26 June 2026

88 Waterloo Road Development

Response to Submissions (Architecture & Urban Design)

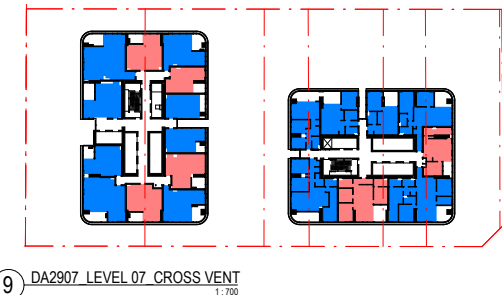
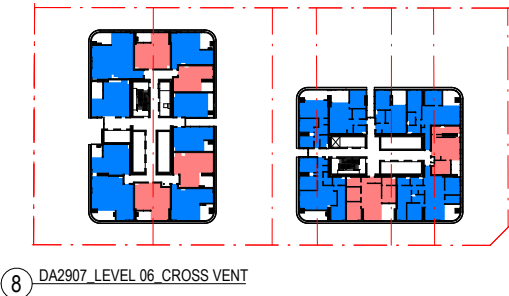
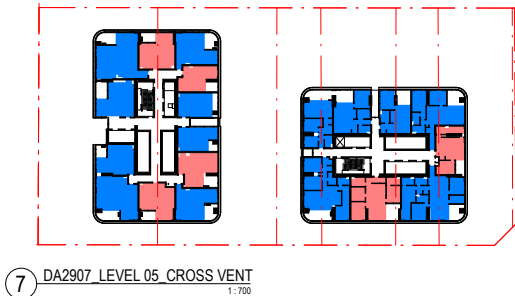
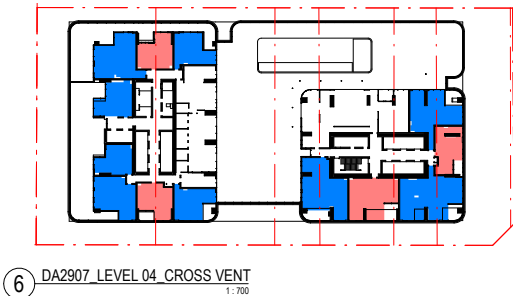
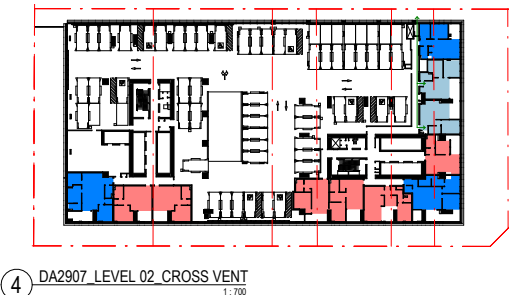
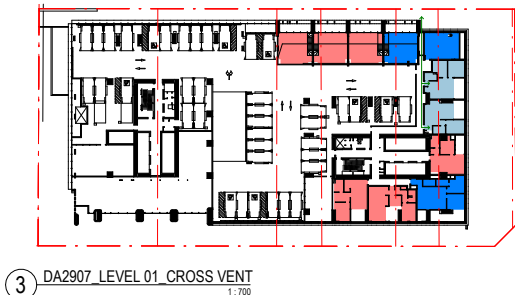
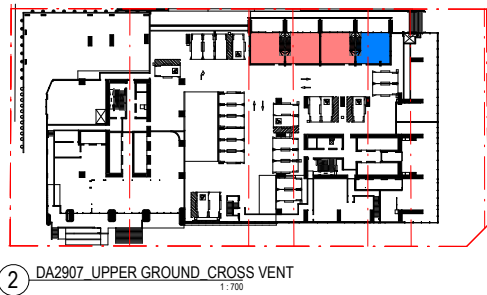
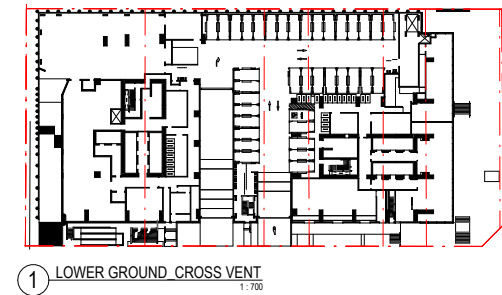
"Cross ventilation is achieved only with reliance on a 'potential cross ventilation design solution' which has not been validated. Drawings illustrate the use of entryways and internal corridors for ventilation."

The drawings below illustrate how ADG Natural Cross Ventilation targets are met.

Many of the units on the lower floors 'sleeve' the above ground parking levels. These make strict compliance with ADG guidance more difficult to meet than a mid-rise building. The lower levels to which the ADG applies cross-ventilation guidance only represent <15% of the units in the building.

The drawings show cross-ventilation is achieved through a) corner apartments and b) deep recesses.

The solution for an additional 4 apartments in the podium along Waterloo Road is to use a ducted plenum to the adjacent corner of the building. An internal louvre inside the apartment will allowing the resident to control the natural flow of ventilation.

Number of Apartments (first 9 storeys)	106
Apartments naturally cross ventilated	64
60.4% (Complies with ADG Guidance)

Level 11-19 Plan

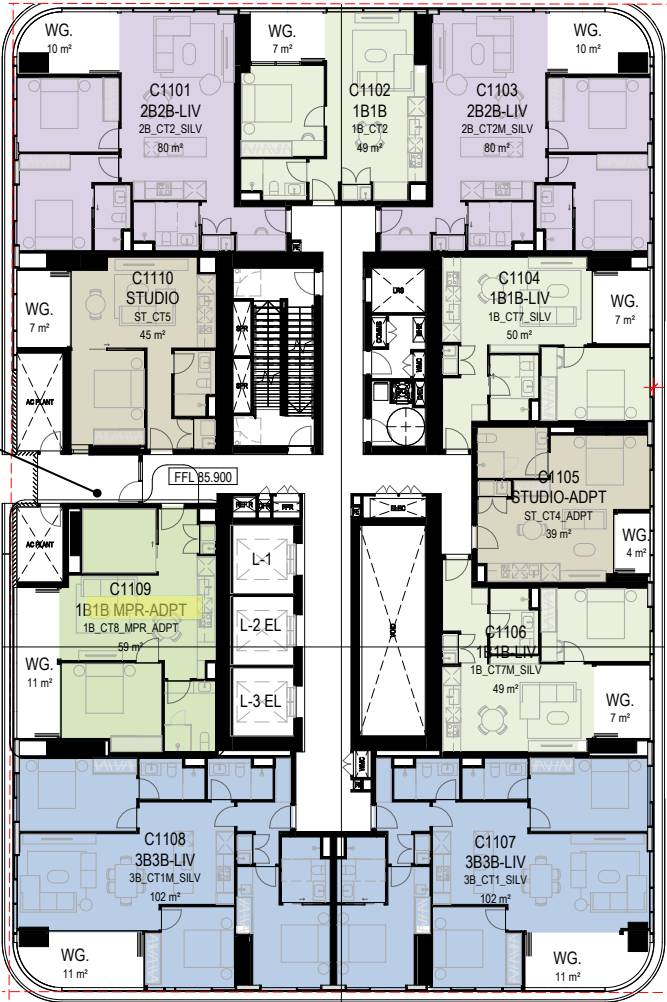
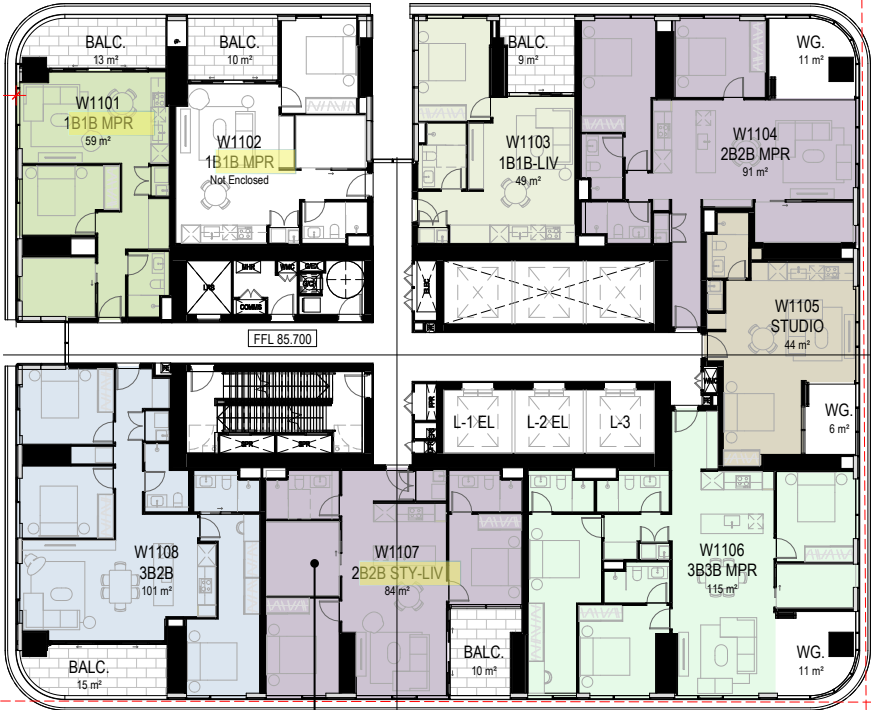
Several dwellings are illustrated as having a habitable MPR (assumed to mean multi -purpose room) that do not have windows.

MPR is an abbreviation for Multi Purpose Room.
This has abbreviation has been added to the abbreviations list on the Project Summary Sheet DA0001.
Apartments indicated as an MPR that have no windows to the MPR have been amended to STR - Store Room on the SSDA plans.

Basement Level 4 Plan

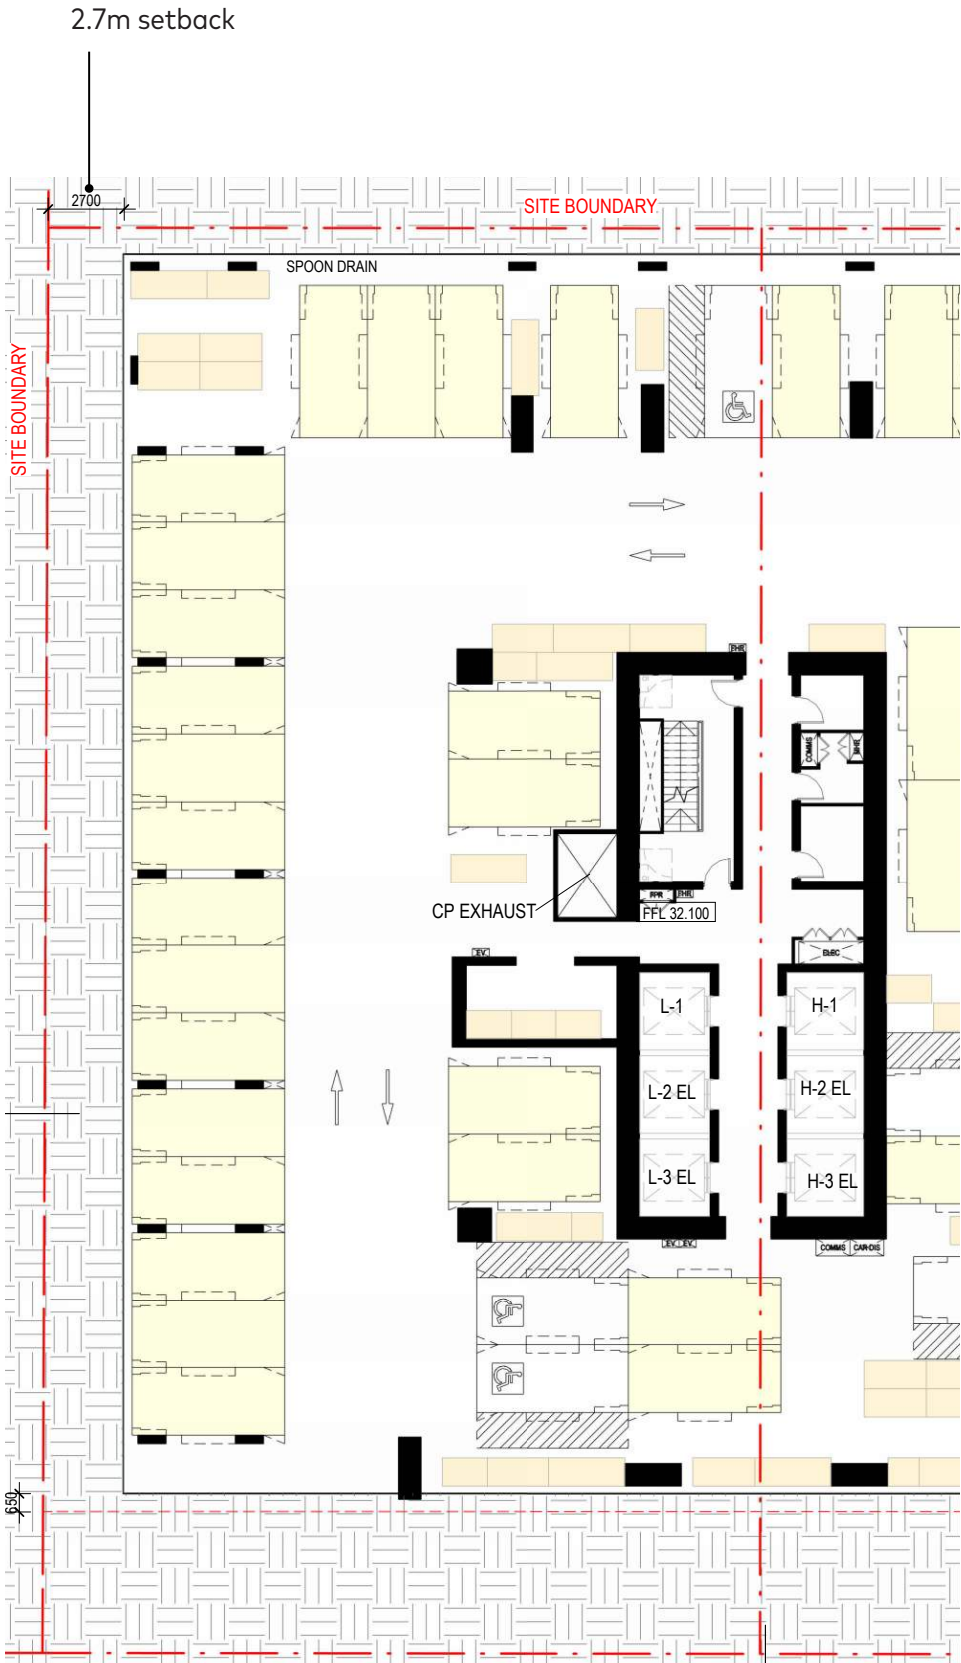
"The proposed 800mm side setback to the southern boundary does not serve as a 'biodiversity corridor' as noted on the landscape masterplan. This setback must be increased to at least 3m to establish a vegetation buffer to help screen the development when viewed from adjoining properties."

Refer to updated Landscape Architect documentation that shows 'biodiversity corridor' note deleted and additional screening vegetation.

In terms of the setback, we have provided a 6m landscaped setback where practicably possible.

The excavation line to the basement has been increased to 2,7m providing a deep soil planting zone along the boundary.

Additionally the roof of the loading dock is landscaped. The planting on structure has a 1.2m deep soil zone that will allow for mature height planting.

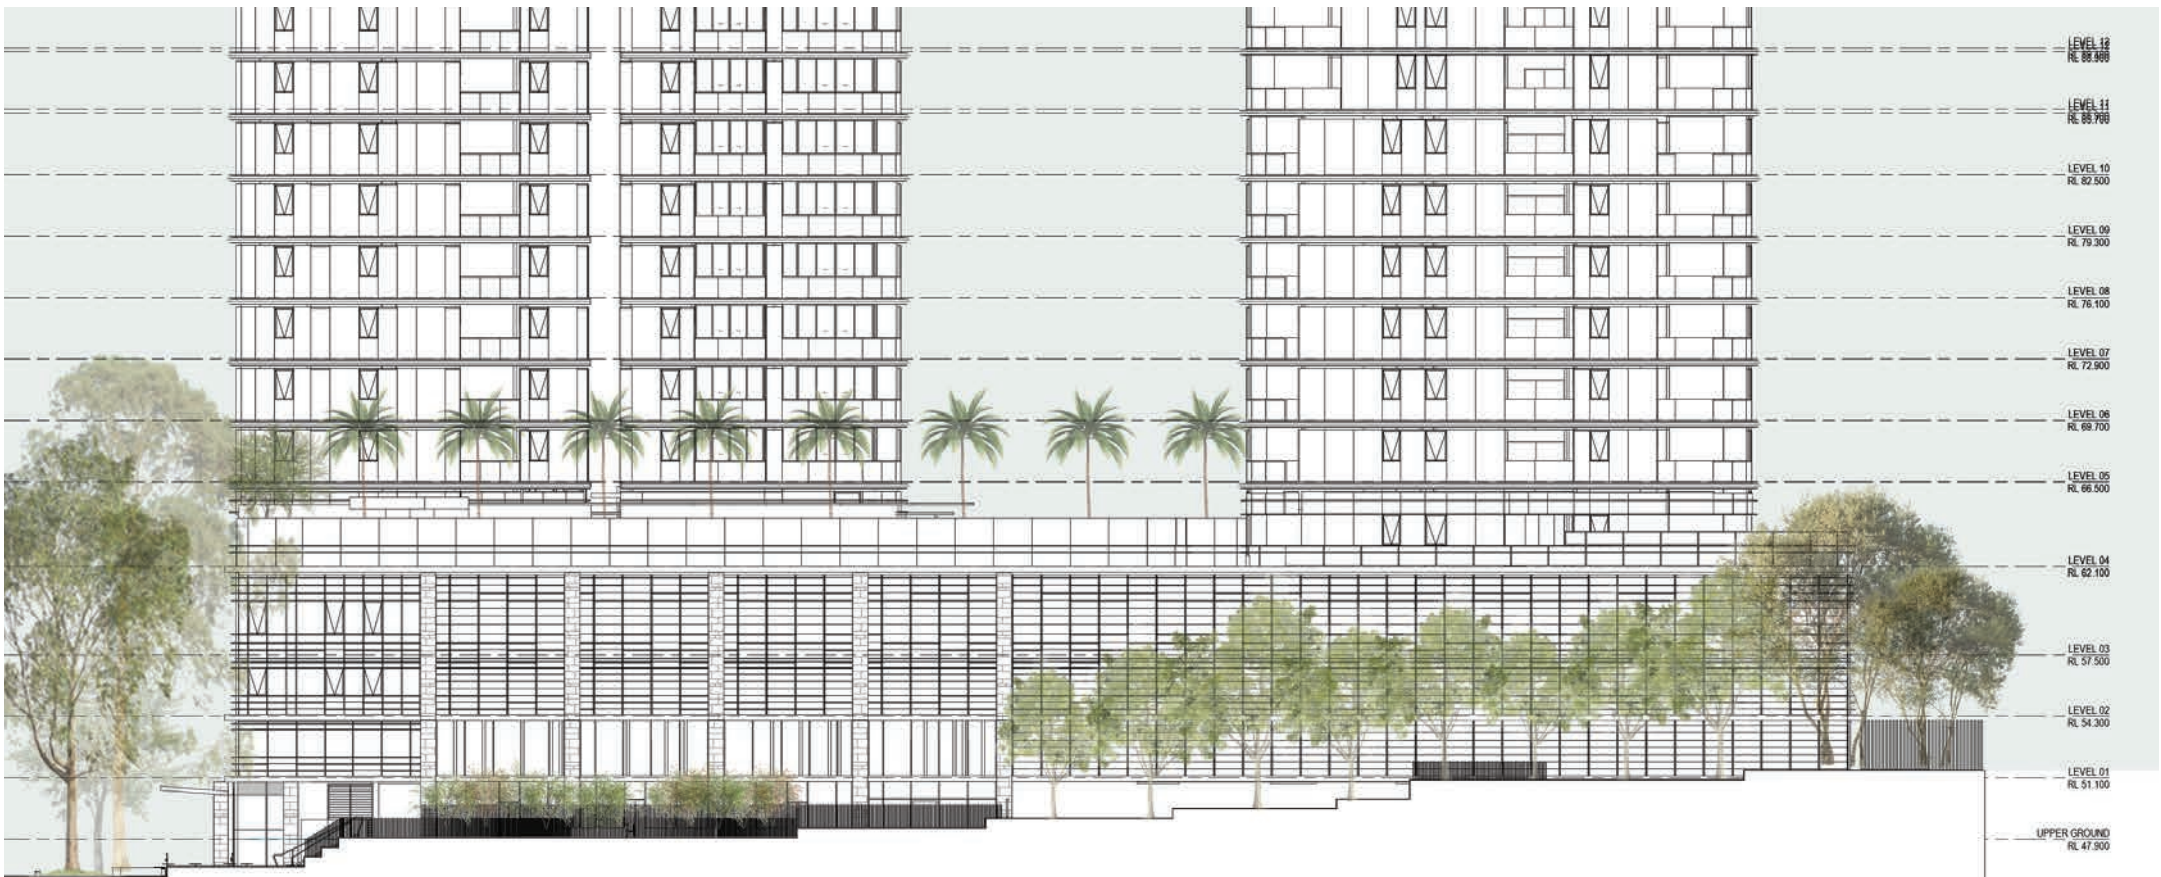
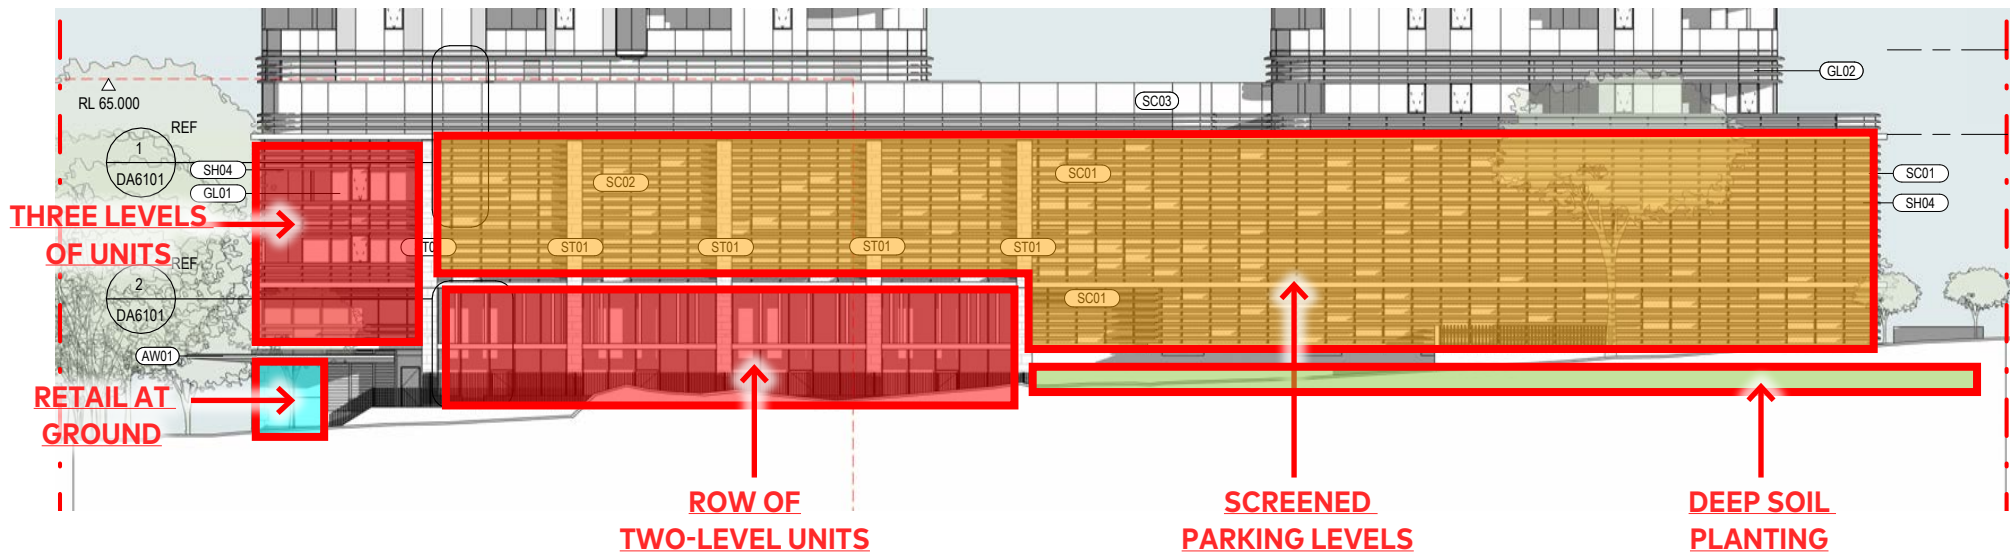
"The proposal's podium interface with Elouera Reserve is suboptimal due to limited setbacks and four levels of car park screening across approximately half of the frontage. While three trees are proposed along this boundary to offset the visual bulk of the podium, their establishment and growth would be constrained by the podium two storeys above and basement parking below. The podium setback to Elouera Reserve must be increased to facilitate tree retention, additional tree planting, improved building interface and reduce perceived bulk."

- Three levels of units above ground level retain on the most prominent north western corner.
- A line of 2-storey dwellings facing onto the park along the half of the western ground level.
- An articulated architectural facade screening the remaining parking and service areas.
- 1.2m deep soil planters along half the western frontage at ground level allow for mature height planting and the appearance that it is an extension of the park. landscaping of the park

Further to this increasing the setback by 2m would not significantly reduce the bulk or scale of the development on Elouera Reserve. The landscaping within Elouera Reserve will also act as a natural screening towards the development.

The proposed design provides activation and connection to the park from the town houses while providing deep soil planting and screening elsewhere. This new urban interface provides a balanced response between public and private, and active and passive spaces.

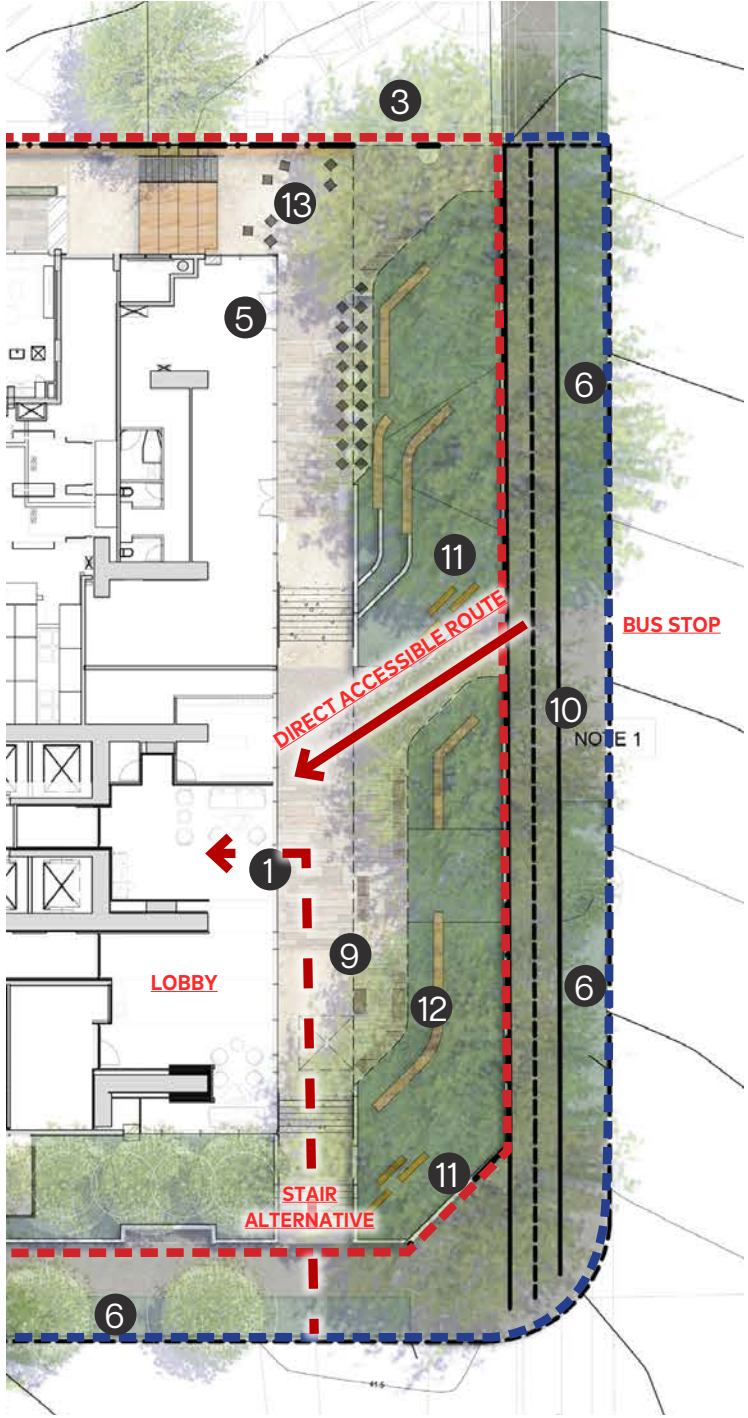
ISSUE
"The accessible entry to the Waterloo Tower lobby is through an informal decked seating area. This does not present as a clear and legible main building entry. The design and location of accessibility points to main residential lobbies must be prioritised to establish a clear and publicly accessible street interface."

RESPONSE
The entry of the Waterloo Tower has been located on the prominent corner of Waterloo Road and Cottonwood Crescent. As can be seen in the image to the right, the entrance will be prominent when viewed from the publicly accessible street interface.

The entrance sequence has been further rationalised to make the accessible route more direct.

The floor level of the lobby is based on the flood levels, and as such there is a significant height difference from street level. While the level difference is unavoidable, we have worked with Landscape Architect Place Design Studio to provide the main accessible entry pathway to the lobby from Waterloo Road in an alignment that maximises deep soil planting and the retention of the existing mature trees, while providing a clear and accessible entry.
